## MEMORANDUM

Date: April 19, 2024  
To: Firstname Lastname, Starlight Developments  
From: Noah Reeder, EIT and Andy Kading, P.Eng., P.E., WATT Consulting Group  
Our File No: 3734.B01  
Subject: 7840 Lochside Drive TIA Addendum

7840 Lochside Drive  
 Transportation Impact Assessment Addendum

Figure 2  
 Proposed Crosswalk Conceptual Design

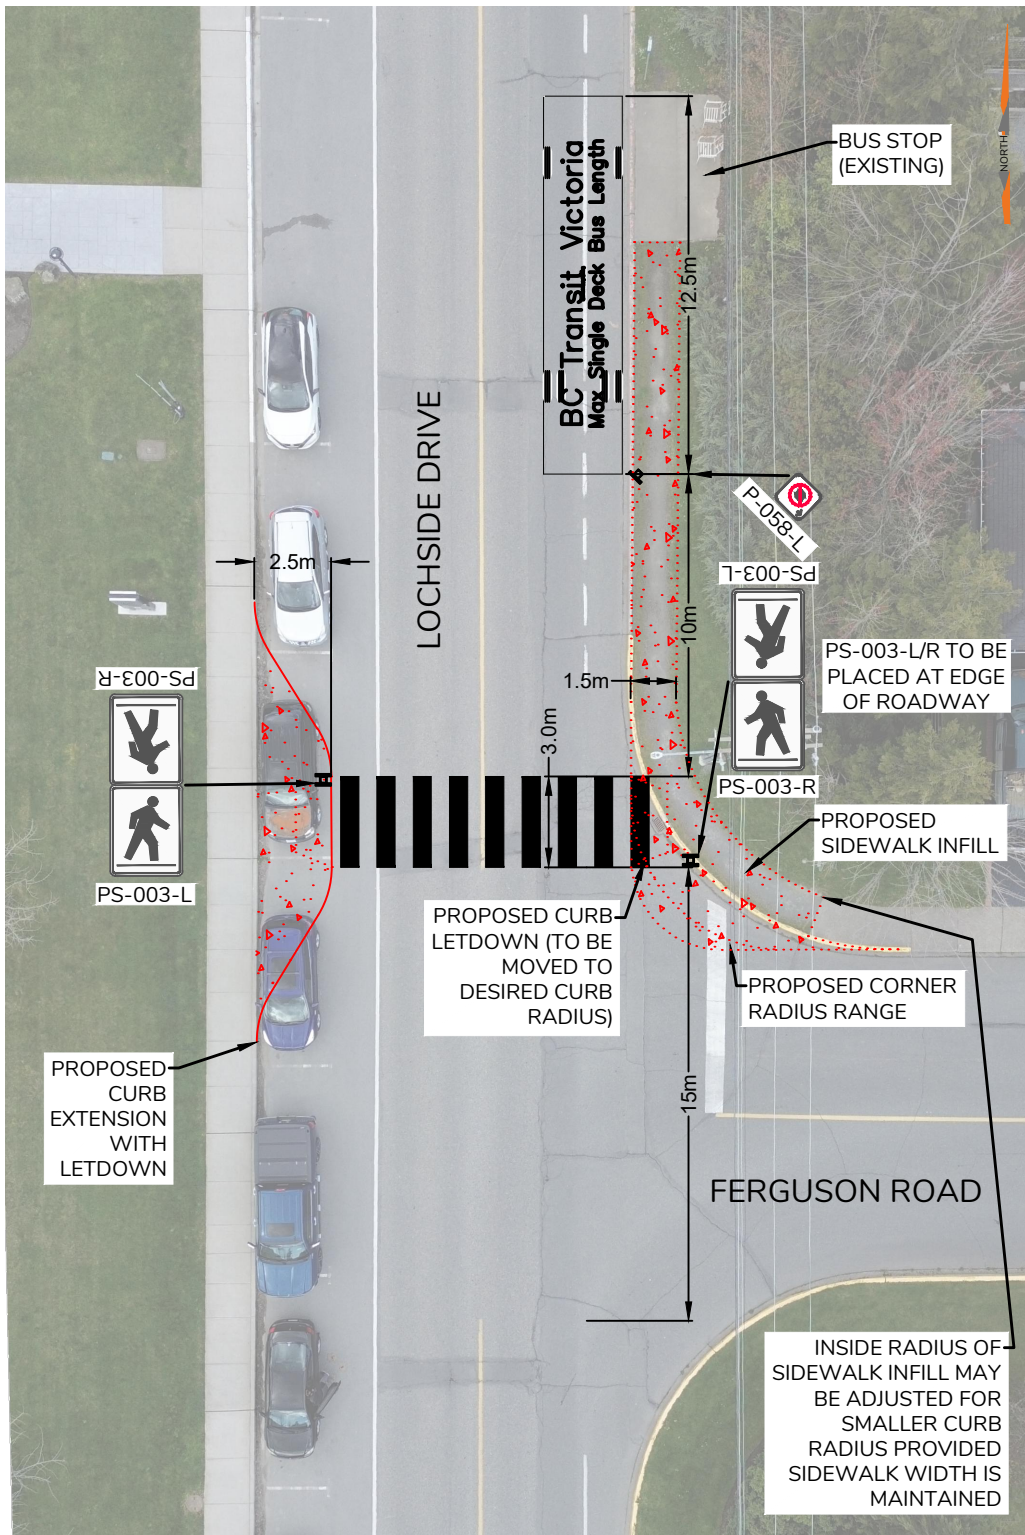
The District proposes to add a signed and marked crosswalk across Lochside Drive at or near Ferguson Road.

distance, the Transportation Association of Canada (TAC)'s *Pedestrian Crossing Control Guide* recommends a standard crosswalk with side-mounted signs. This recommendation is contingent on the construction of a curb extension in the southbound parking lane (west side of road) to reduce the exposed crossing distance for pedestrians.

The proposed location of this crosswalk was chosen to minimize loss of on-street parking, align with existing street lighting, and to ensure the necessary northbound stopping prohibitions are sufficiently away from the bus stop north of the intersection. Two (2) southbound on-street parking spaces will need to be removed for a curb extension with TAC's minimum recommended radii and a crosswalk width of 3.0 m.

- Side-mounted signs (PS-003-L/R) mounted back-to-back on each side of Lochside Drive for northbound and southbound traffic for a total of four (4) signs on two (2) poles.
- Zebra crosswalk markings
- Northbound stopping prohibition for a minimum of 10 m north of the crosswalk
  - TAC would also recommend a northbound stopping prohibition 15 m south of the crosswalk; however, this distance is entirely within the Lochside Drive / Ferguson Road intersection where vehicles are already prohibited from stopping.

WATT recommends that a standard crosswalk with side-mounted signs mounted back-to-back be implemented on the north leg of the Lochside Drive / Ferguson Road intersection with an extension of the west curb into the existing parking lane.

- Side-mounted signs (PS-003-L/R) mounted back-to-back on each side of Lochside Drive for northbound and southbound traffic for a total of four (4) signs
- Zebra crosswalk markings
- Northbound stopping prohibition for a minimum of 10 m north of the crosswalk
